NFSEG Peer Review

Task A.3 Draft Initial Comments

Draft Initial Comments for HSPF Model

Draft Initial Comments for MODFLOW Model

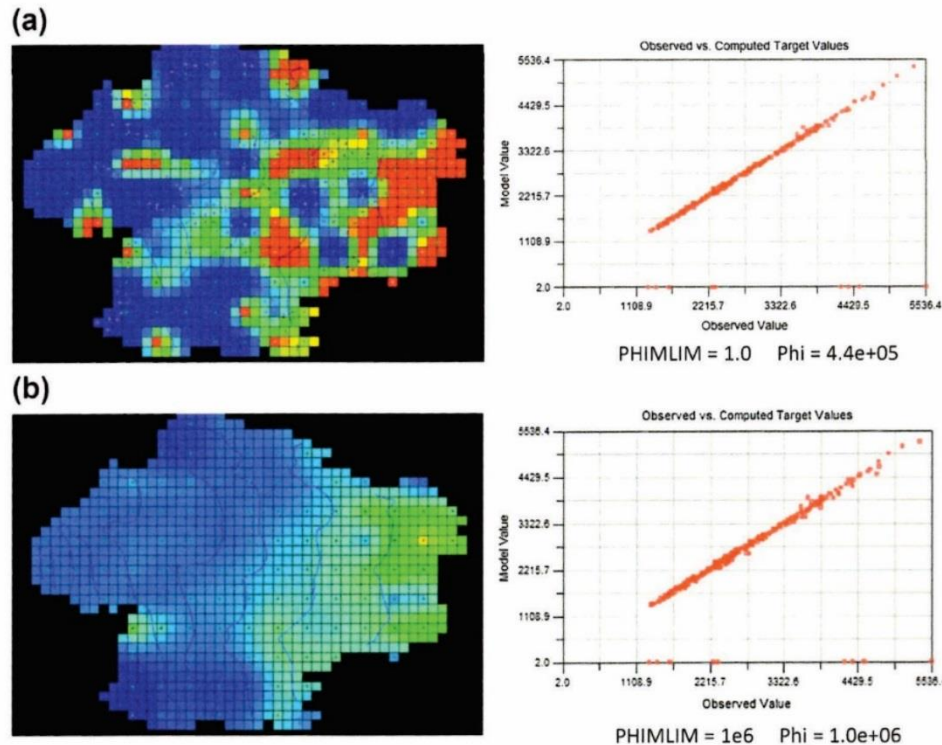
- The methodology used in setting up the PEST calibration should be discussed in greater detail.
- An example was taken from the book Applied Groundwater Modeling:
